NLS2015103
September 8, 2015

Subject: License Amendment Request to Replace Figure with Text in Technical Specifications
Cooper Nuclear Station, Docket No. 50-298, DPR-46

License Amendment Request to Replace Figure with Text in Technical Specifications

Figure 4.1-1 (page 1 of 1)
Site and Exclusion Area Boundaries
and Low Population Zone

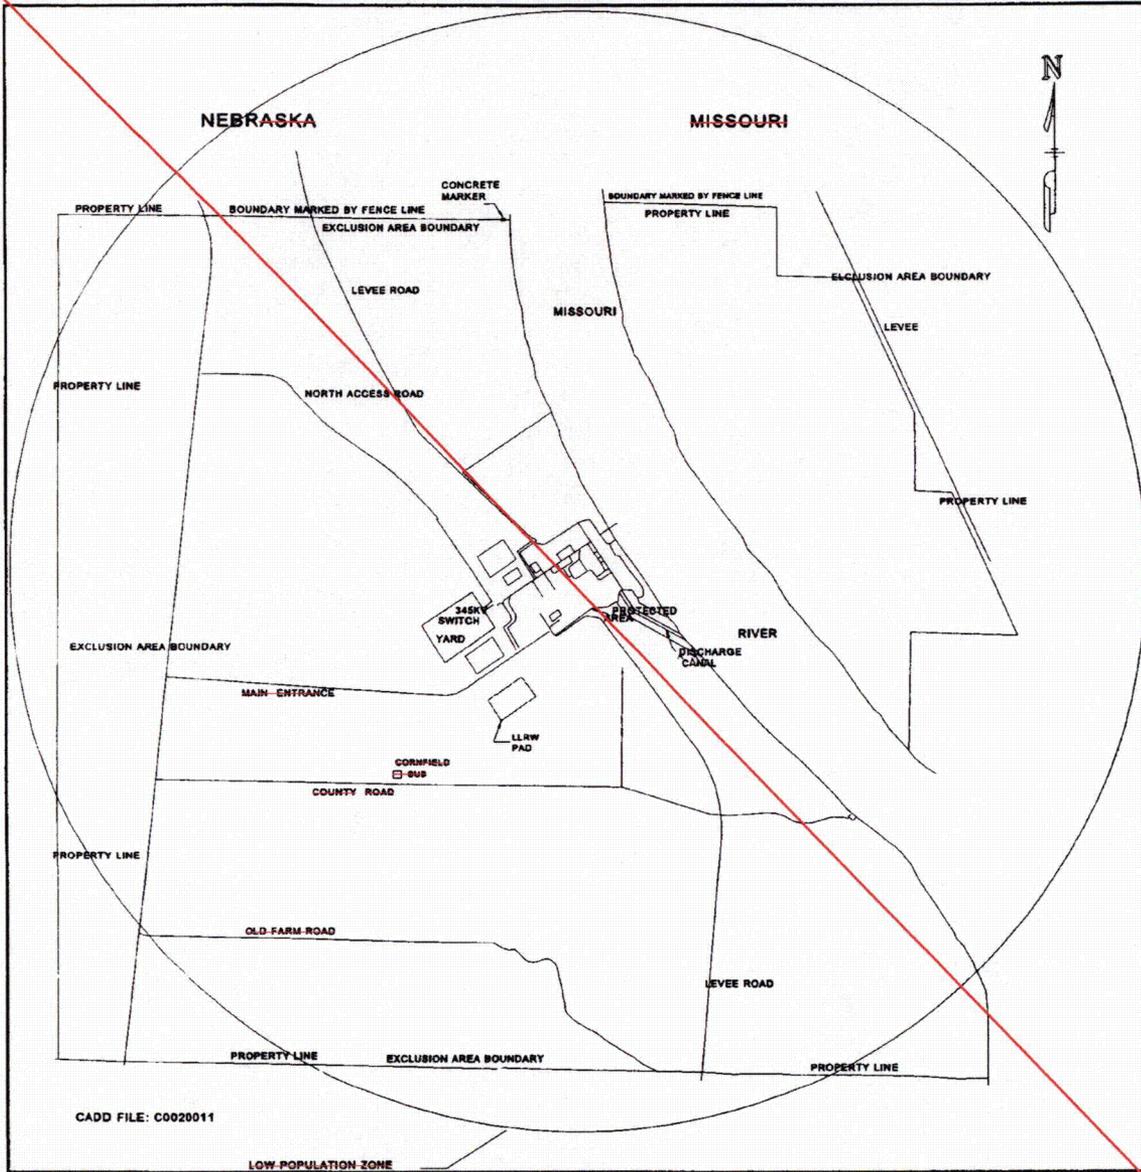
TS Section 4.0, Design Features, Page 4.0-1, by adding a description of the site location in Section 4.1, Site Location. Delete Page 4.0-3, which contains Figure 4.1-1, Site and Exclusion Area Boundaries and Low Population Zone. This figure will remain in the Offsite Dose Assessment Manual.

~~4.1.1 Site Area and Exclusion Area Boundary~~

~~The Site and Exclusion Area Boundaries coincide with each other and shall be as shown on Figure 4.1 1.~~

~~4.1.2 Low Population Zone~~

~~The low population zone is all the land within a circle with its center at the reactor and a radius of 1 mile as shown on Figure 4.1 1.~~

The station site is located in Nemaha County, Nebraska, on the west bank of the Missouri River, at river mile 532.5. This part of the river is referred to by the Corps of Engineers as the Lower Brownville Bend. The site consists of 1,351 acres of land owned by NPPD. About 205 acres of this property is located in Atchison County, Missouri, opposite the Nebraska portion of the station site. The land which the station physically occupies is bounded by the Missouri River on the east and by privately-owned property on the north, south, and west. The boundary of the exclusion area is delineated by the property lines. The distance from the reactor center to the boundary of the low population zone is a radius of 1 mile.

The station site is located in Nemaha County, Nebraska, on the west bank of the Missouri River, at river mile 532.5. This part of the river is referred to by the Corps of Engineers as the Lower Brownville Bend. The site consists of 1,351 acres of land owned by NPPD. About 205 acres of this property is located in Atchison County, Missouri, opposite the Nebraska portion of the station site. The land which the station physically occupies is bounded by the Missouri River on the east and by privately-owned property on the north, south, and west. The boundary of the exclusion area is delineated by the property lines. The distance from the reactor center to the boundary of the low population zone is a radius of 1 mile.
